Staff Presentation to the
Portland Design Commission

LU15-268668 DZM

PSU Stott Center/New Viking Pavilion

March 3, 2016

central city plan district development standards diagrams

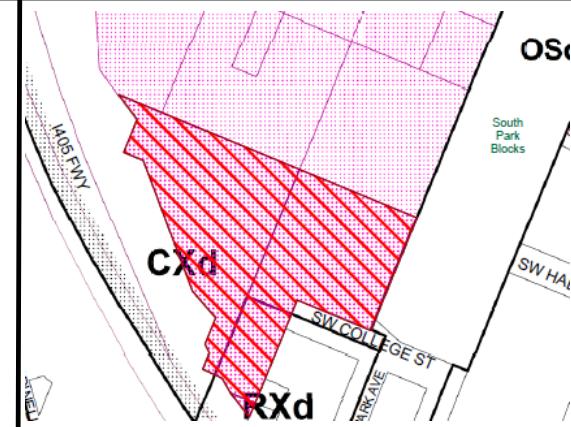
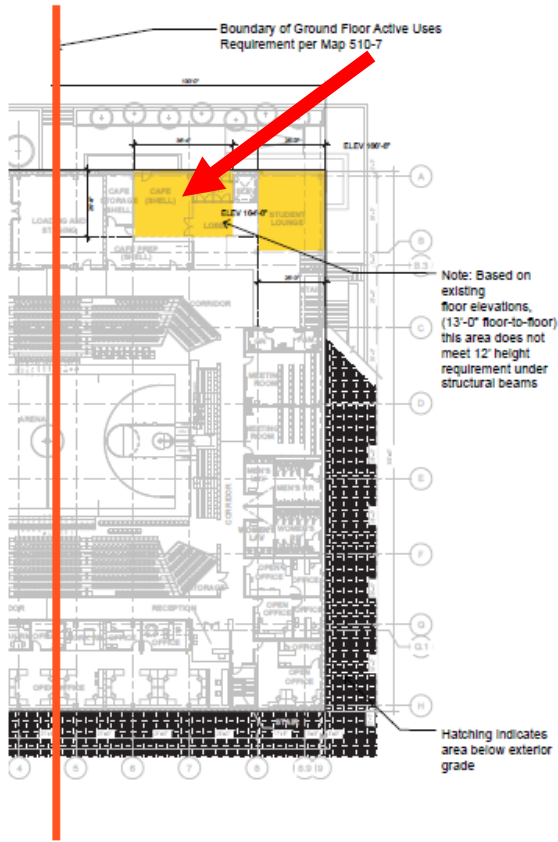
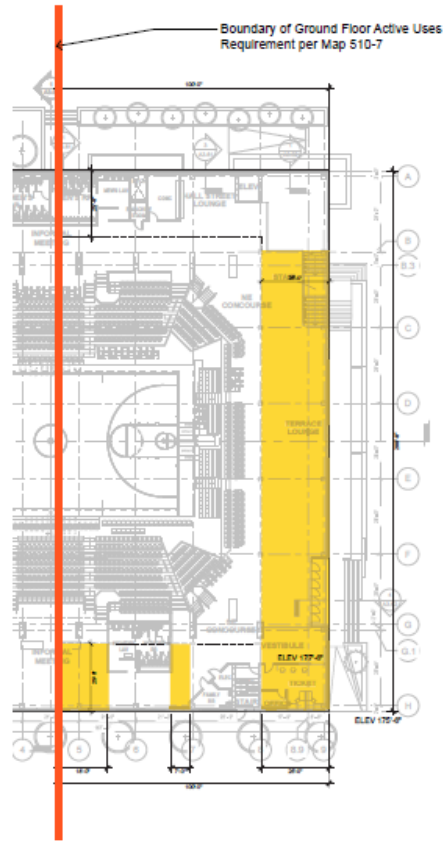
REQUIRED -

Windows must extend 50% of length and 25% of area on ground floor walls.

PROPOSED -

SW Hall St: 42% of length; 33% of area (length does not meet)

Ground Floor Active Uses

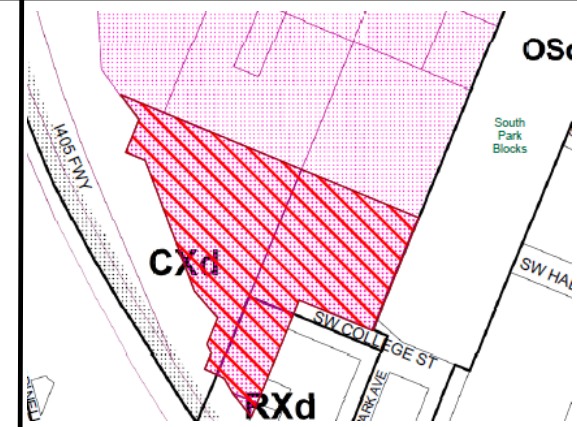
REQUIRED – Applies to the east ½ of block facing SW Park
 Ground floor active use must be provided along 50% of length on all street frontages; 25' deep, 12' clearance, street facing w/ windows & doors.

PROPOSED -

SW Hall St: 55% of length has 25' depth, but 32% of length has only 10'-6" available height below existing beams. (does not meet 12' min clearance)

#1 BES - PW permit

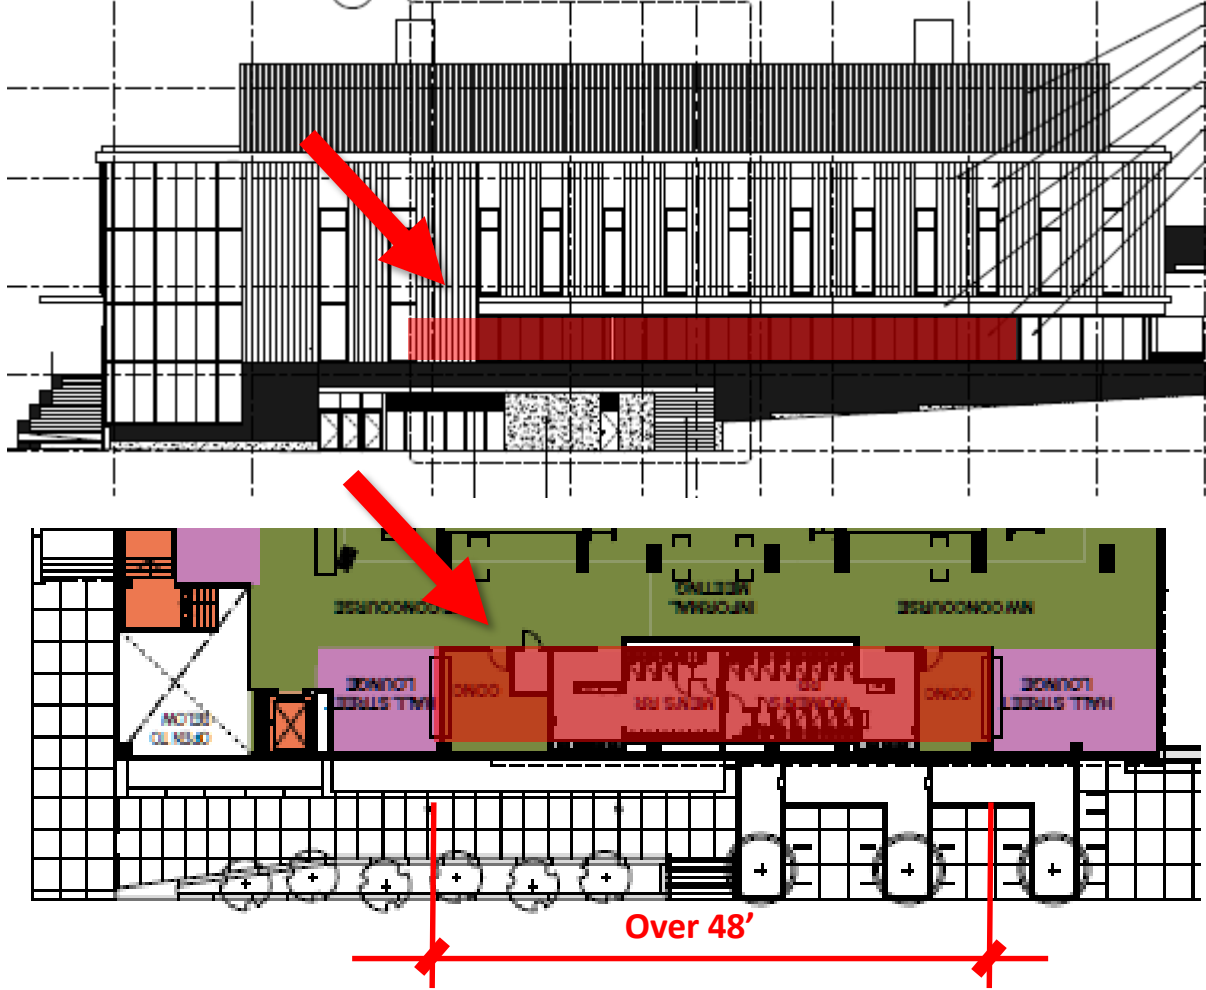
Prior to BES approval of LU, the applicant must obtain BES approval of the Public Works Permit 30% Concept Development plans.

#2 SW Hall – Frontage Uses

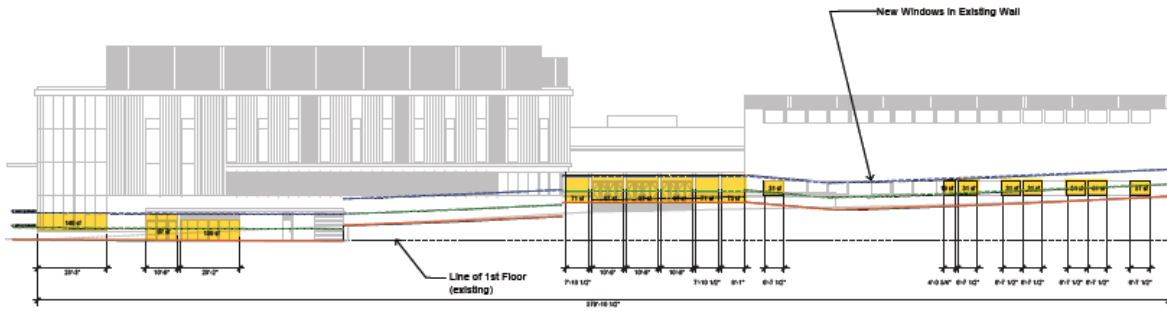
At the concourse level fronting SW Hall, in-active uses (concession and restroom facilities) take up a large stretch of the street frontage.

Among the CCFGs to consider are: A8, B5, C1

#2 SW Hall - GF Windows Mod

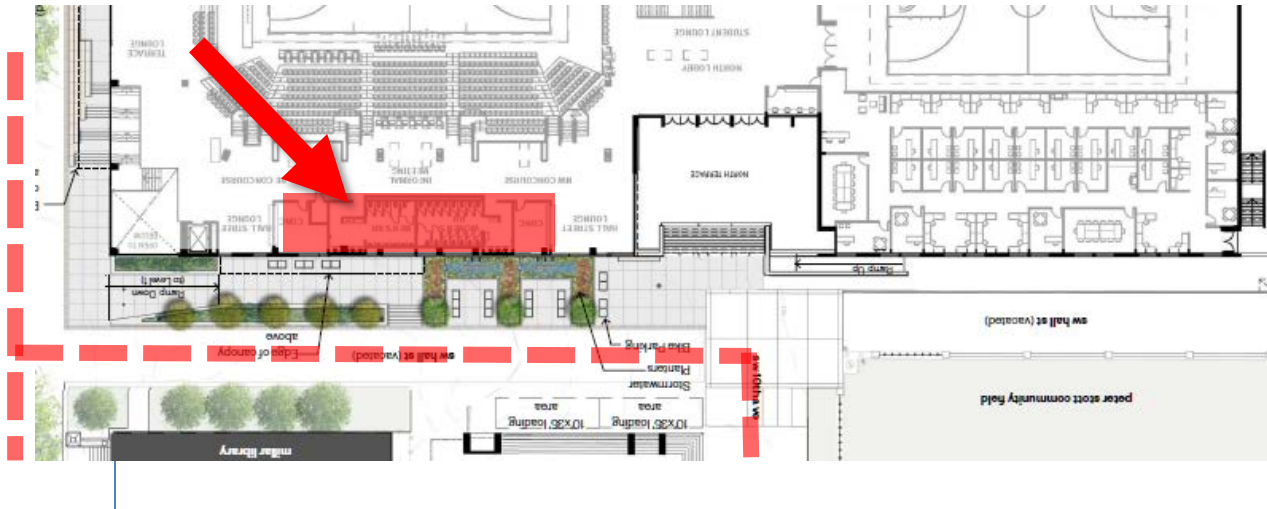
42% of length does not meet 50% req'mt. along the street frontage. Additionally, the majority of the frontage facing the active half of SW Hall is spandrel panel with inactive uses behind.

Among the CCFGs to consider are: A8, B1, B4, B6, C9 as well as the Purpose statement of the standard

#2 SW Hall - Streetscape

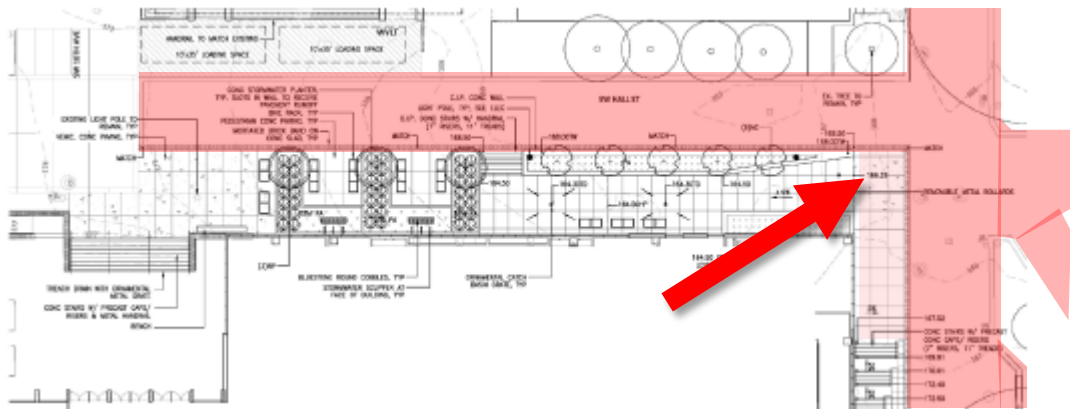
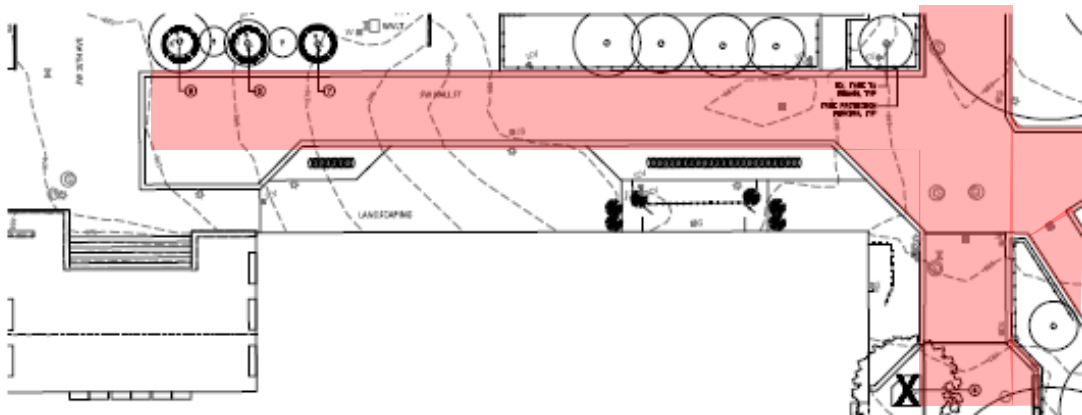
At the corner of SW Park and SW Hall, the paving treatment looks to constrict rather than encourage pedestrian movement along Hall.

Among the CCFGs to consider are: B1 and C9.
